Assessing new nuclear power station designs

Generic design assessment of Hitachi-GE's Advanced Boiling Water Reactor

Assessment report - AR03 Best available techniques

12 December 2016

Figure 1: Diagrammatic representation of gaseous, liquid and solid waste arisings within the UK ABWR (Hitachi-GE, 2016c).

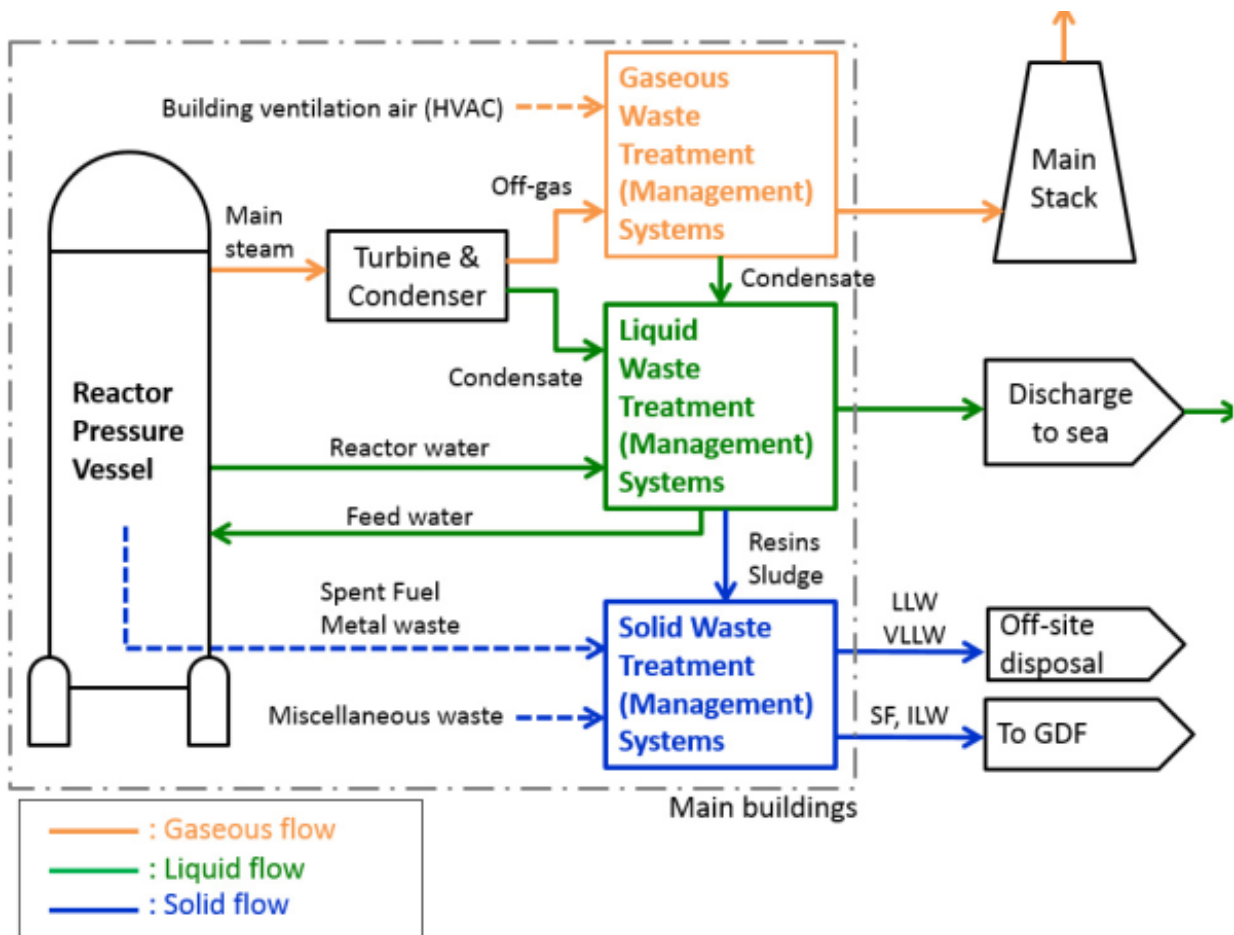
Steam used in the turbine gland steam system (TGS) is derived from the condensate system and is one source of tritium discharge (see discussion of Argument 2e, below). This source is not shown in Figure 1. We raised a RO regarding discharges from the turbine gland steam system (RO-ABWR-0071, 'Turbine Gland Steam System: Discharges and Optimisation'), which remains open at the time of writing this report.

The HVAC system is identified as 'building ventilation air' in Figure 1. The functions of the HVAC system for the management of gaseous radioactive wastes are limiting and containing the possible release of radioactive materials from plant and equipment in a room/area; and, where necessary, filtering contaminated air prior to its discharge into the atmosphere.

Figure 2: Diagrammatic representation of the configuration of the Liquid Management System (Hitachi-GE, 2016a).

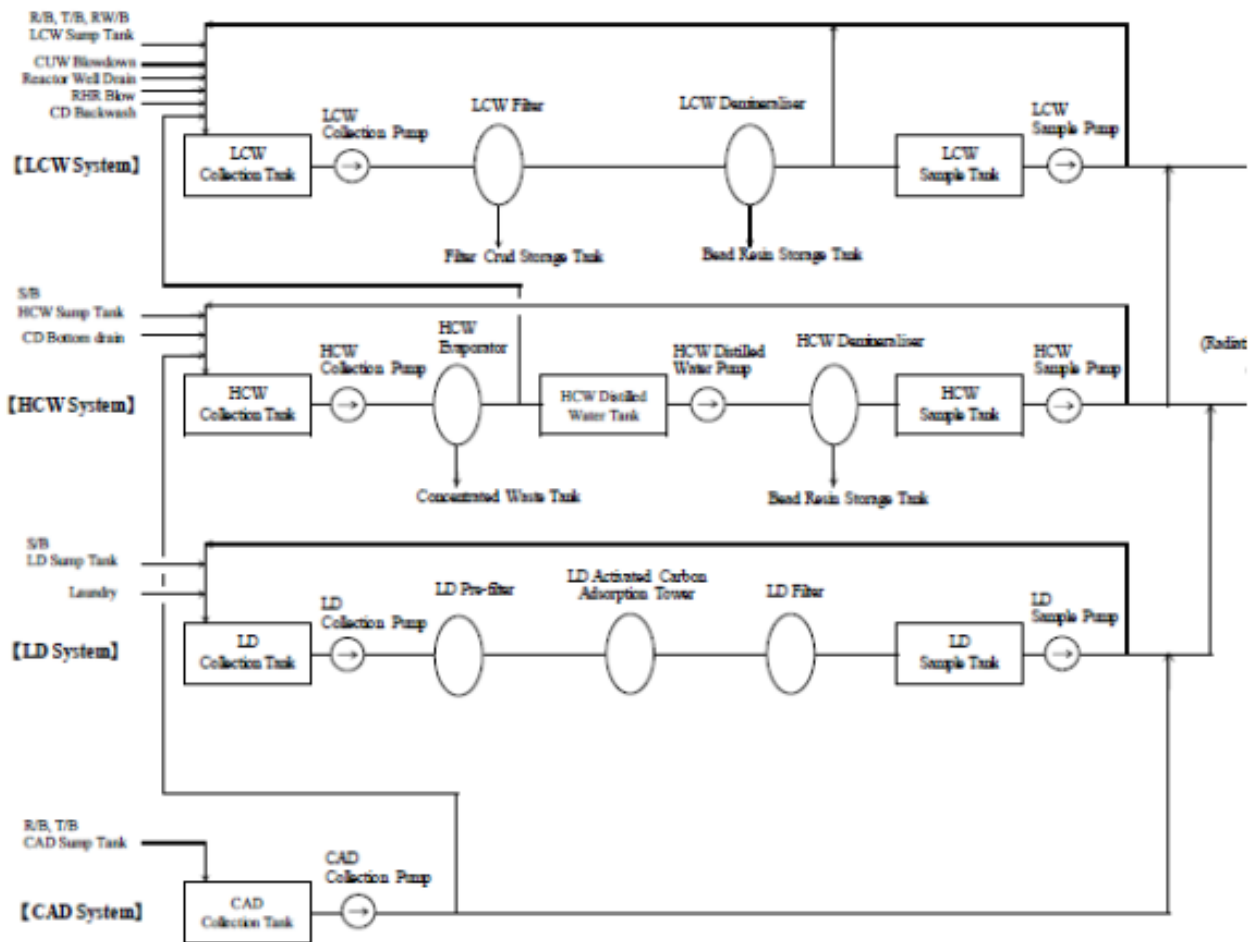
The LCW consists of filters for removing particulates, and demineralisers for removing ionic species, and sampling pools. Treated liquids are returned to the CST so they can be recycled rather than discharged.
